**UNIVERSITY OF MISSOURI – COLUMBIA**

**RESEARCH REACTOR**

**RESPONSES TO NRC REQUESTS FOR ADDITIONAL  
INFORMATION RELATING TO LICENSE RENEWAL**

SUBJECT: Written communication as specified by 10 CFR 50.4(b)(1) regarding responses to the  
“University of Missouri at Columbia – Request for Additional Information Re: License  
Renewal, Safety Analysis Report, 45-Day Response Questions (TAC No. MD3034),”  
dated June 1, 2010

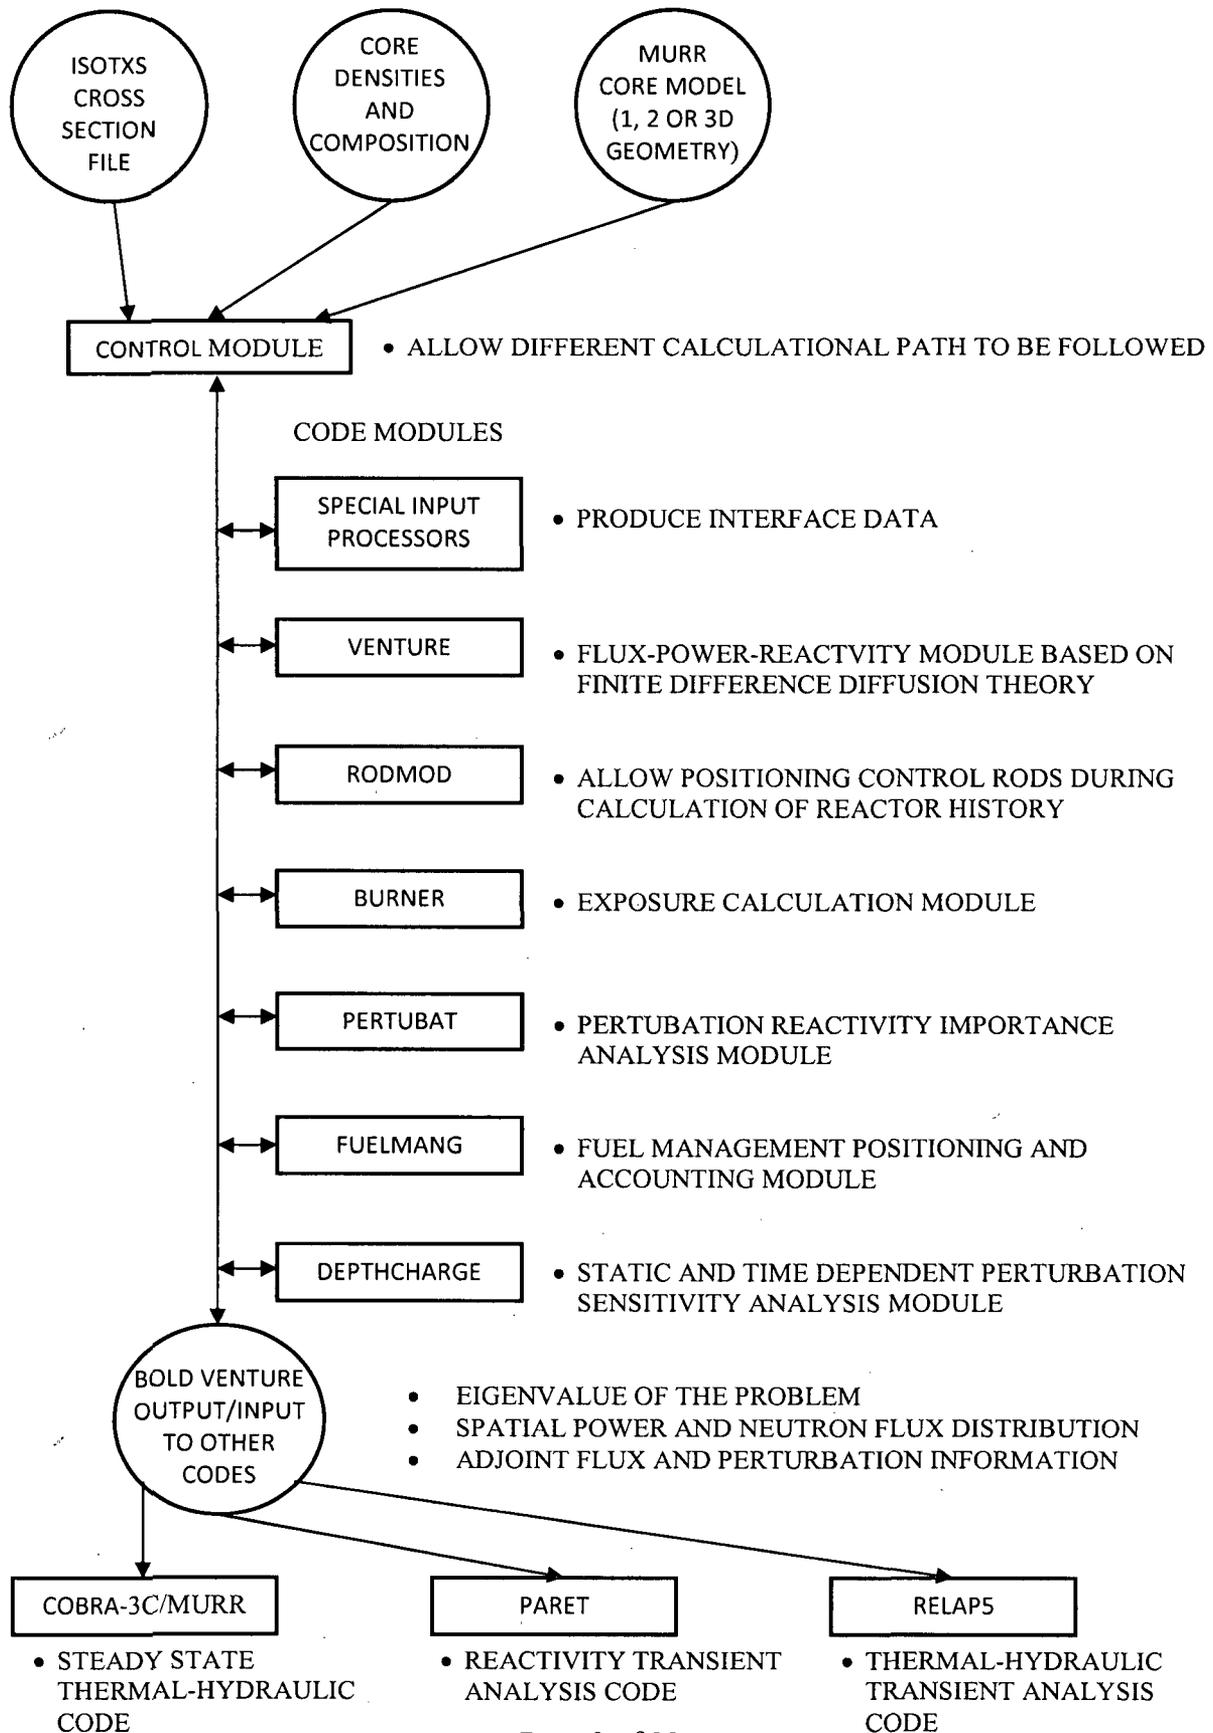
- a. *Page 4-30. Figure 4.8 appears to show details of AMPX-II and not the computational system BOLD VENTURE IV as stated in the text. Provide a figure similar to Figure 4.8 which illustrates components of BOLD VENTURE.*

Attached is a figure showing the various computational modules of BOLD VENTURE.
